**KARACHI MUNICIPAL CORPORATION.****BUILDING SECTION.****REVIEW FORM.**

- PROPOSED SHOP ON PLOT 24 -
- S.S. M.M.5 MUCHHIMIANI QUARTER -
SCALE 8" = 1"

With reference to your application dated 22-5-36
with a plan for the proposed building/additions and alterations on plot
No. 24, Survey Sheet No. M.M.5 Wachi M. Quarter
I have to request you to comply with the following requirements:—

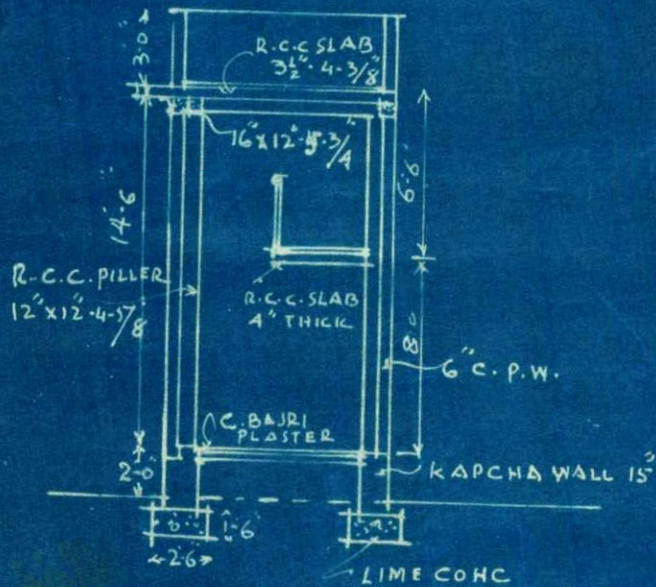
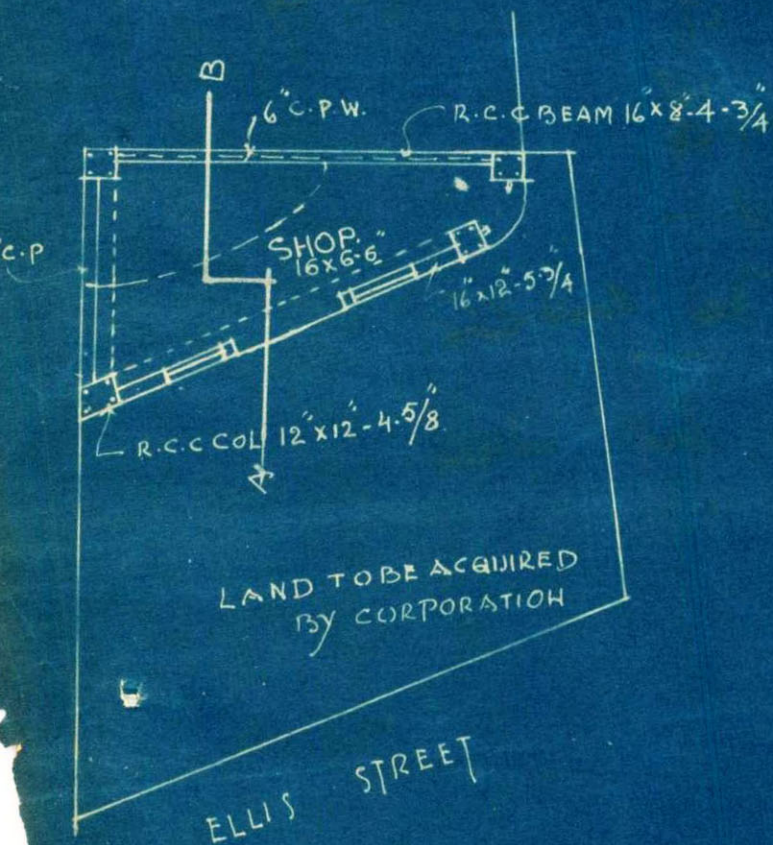
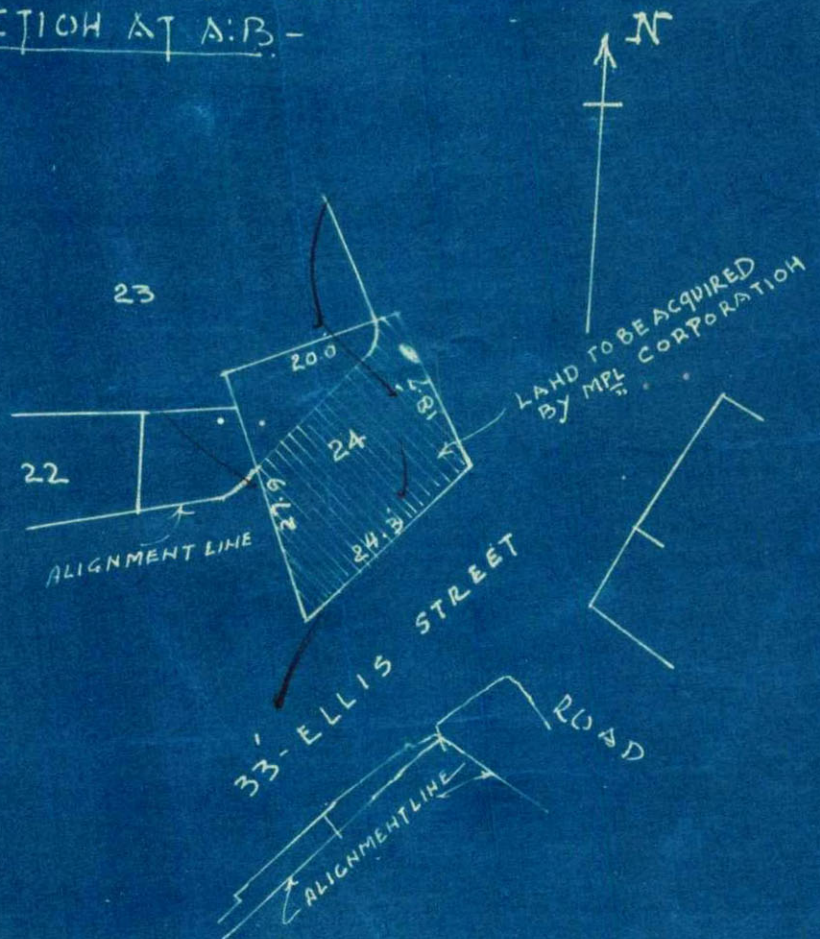
1. Area of loft must be given, it must not cover more than 1/3rd the floor area of shop
2. Height of the loft to be 7' ~~10'~~ instead of 6.6"
3. R. C. C. slabs less than 4" cannot be permitted

- (1) area of loft has been given, it does not exceed $\frac{1}{3}$ ^{few} 1/5 area of slop.
- (2) Height of Loft will be 7-0 as corrected in plans.
- (3) Thickness of R.C.C. slab has been proposed and corrected as 4".

- PROPOSED SHOP ON PLOT 24 -
 - S.S. M.M.5 MUCHHI MIANI QUARTER -
 SCALE 8" = 1"

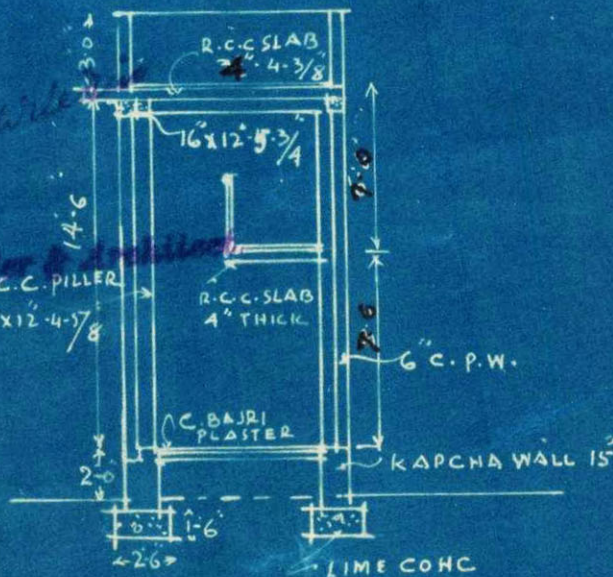
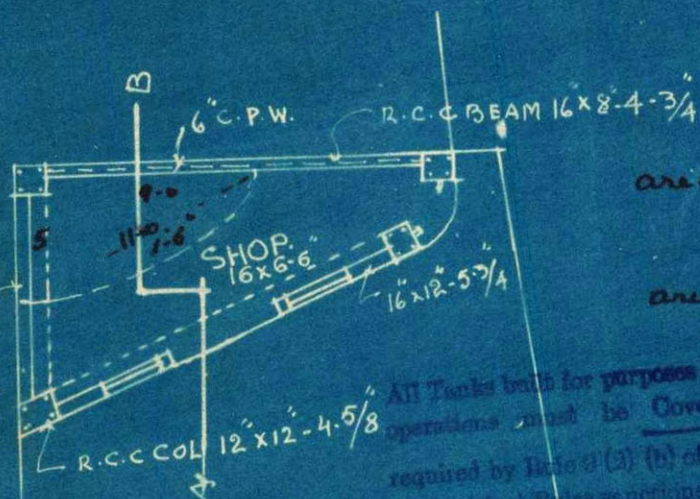
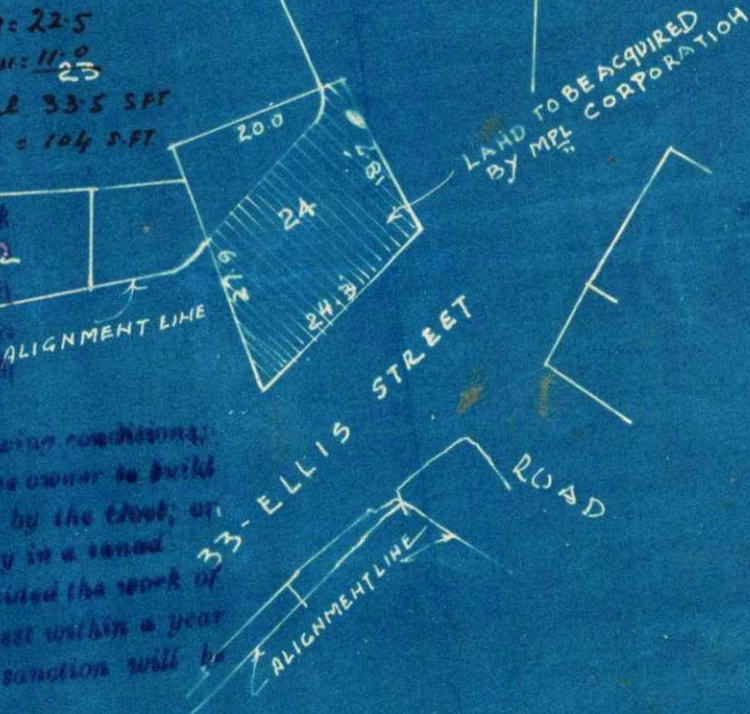
Pl. report what will be the net area of plot left after alignment land is set back.

The area after alignment remains only 15 Sq. yds.

Area of Loft $\frac{1}{2} \times 5 \times 9 = 22.5$
 $\frac{2}{3} \times 1.6 \times 11 = 11.0$
 Total 33.5 SFT
 Area of Plot $16 \times 6.5 = 104$ SFT
